SOUTHEASTERN OAKS PHASE 2

Applicant's Request:

Specific Parcel Master Plan (SPMP) approval for the Southeastern Oaks Phase 2 residential development. The project is comprised of 122 residential units with 2 different lot types.

Updated: April 7, 2014

Secondary Emergency Entrance

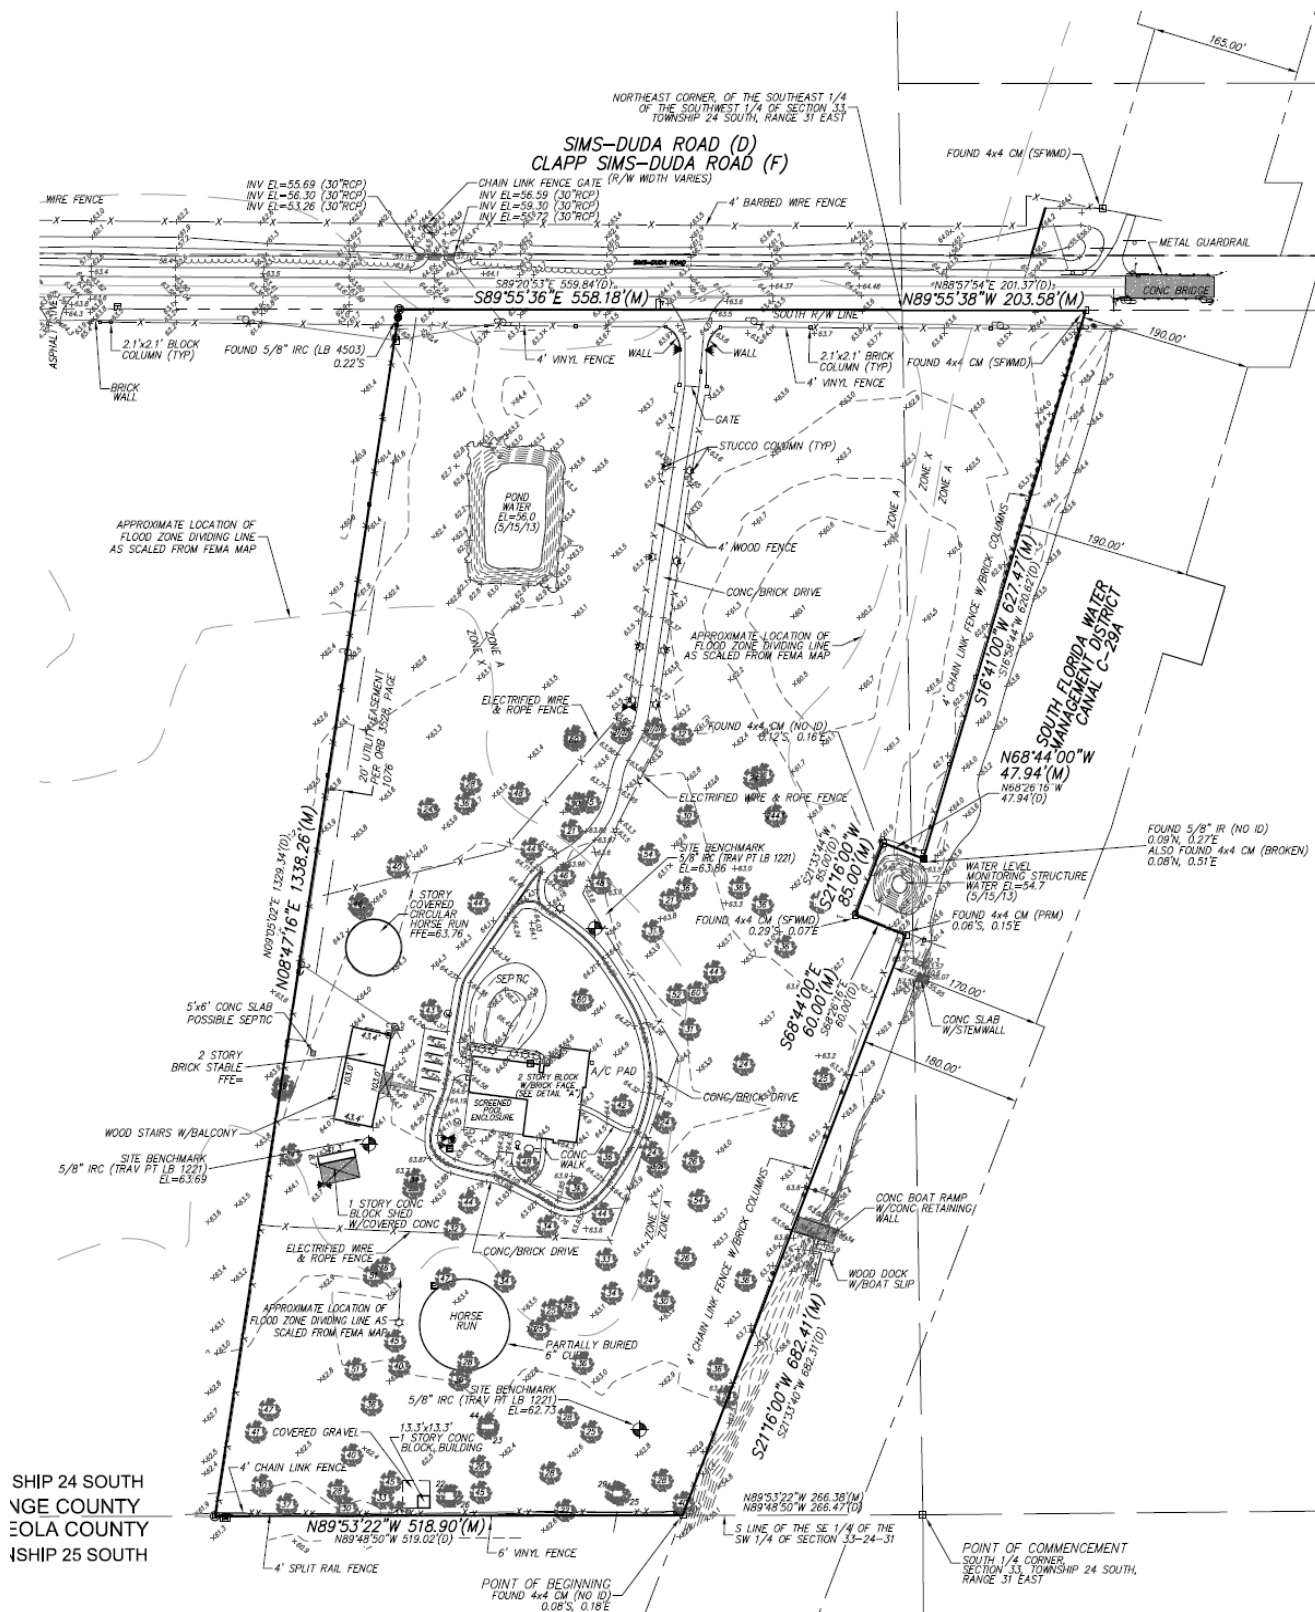
According to Transportation Planning Condition #7, the development shall be constructed such that at least one of the two cul-de-sacs adjacent to Clapp-Simms-Duda Road can be used as access to the development for emergency vehicles in the event of blockage at the main entranceway. The applicant has indicated that they will provide a breakaway gate for at least one of the cul-de-sacs depicted on the plan.

The development shall be constructed such that at least one of the two cul-de-sacs adjacent to Clapp-Simms-Duda Road can be used as access to the development for emergency vehicles in the event of blockage at the main entranceway.

LANDSCAPE PLAN

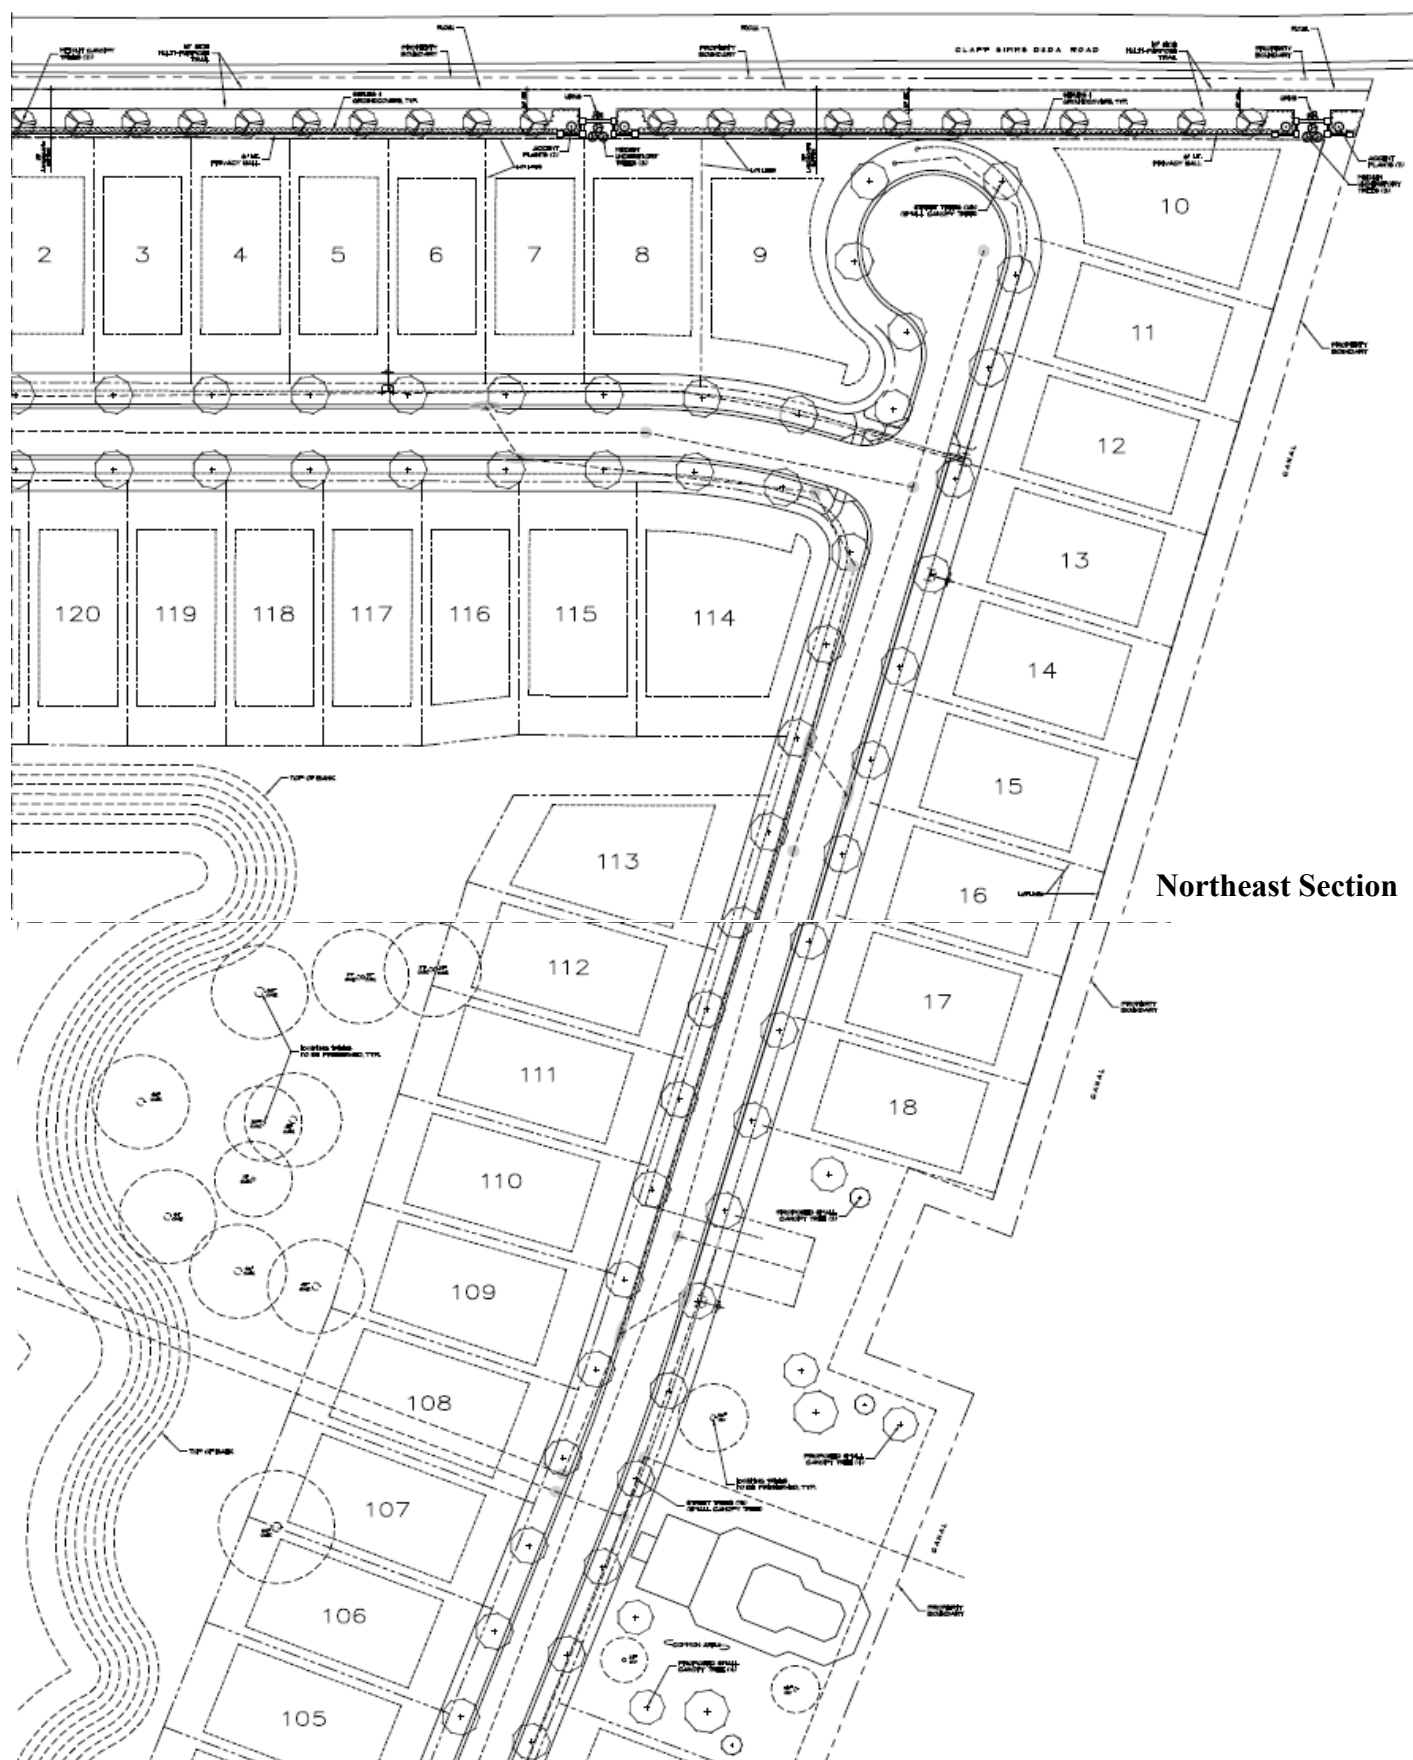
The applicant submitted a landscape plan with this application. The landscape plan can be found on pages 10-12. The landscape plan shall be developed in accordance with Chapter 60 Part 2 of the LDC. Individual lots will be reviewed at the time of building permit submittal. Street trees adjacent to single family lots may be installed concurrent with the home's landscaping. Street trees adjacent to common areas shall be installed concurrent with the infrastructure.

The landscape plan shall be developed in accordance with Chapter 60 Part 2 of the LDC. Individual lots will be reviewed at the time of building permit submittal. Street trees adjacent to single family lots may be installed concurrent with the home's landscaping. Street trees adjacent to common areas shall be installed concurrent with the infrastructure.

SECTION A-ATYPICAL 50' R.O.W. PAVEMENT SECTION

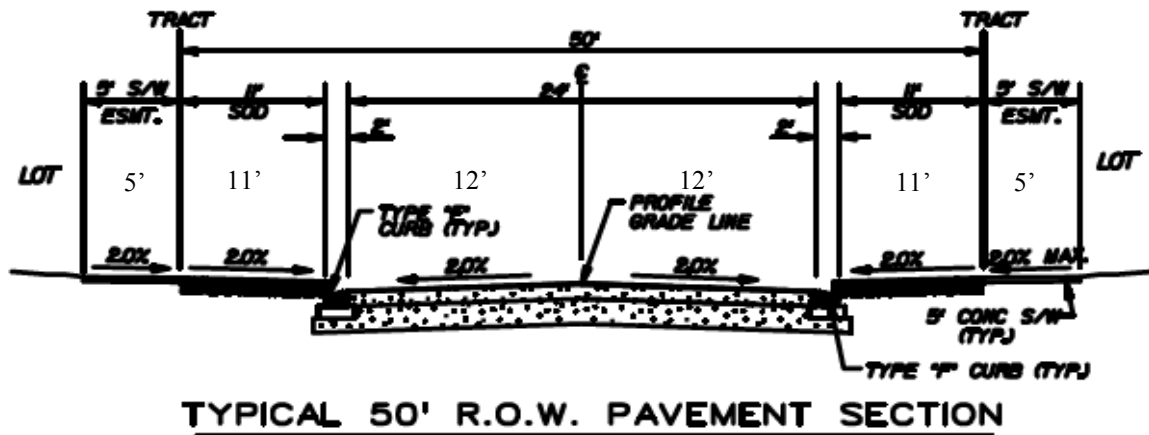
At the time of SPMP submittal, the street cross section shows a 5 foot sidewalk easement in the front yard. The front setback is typically measured assuming the sidewalk is in the right of way. In this case, the effective setback from back of sidewalk will be 20 feet, which is acceptable because it exceeds the PD minimum of 16 feet. After discussion with the applicant, they would prefer to have the sidewalks in the right-of-way instead of within the property. The SPMP and preliminary plat shall be revised to reflect this change.
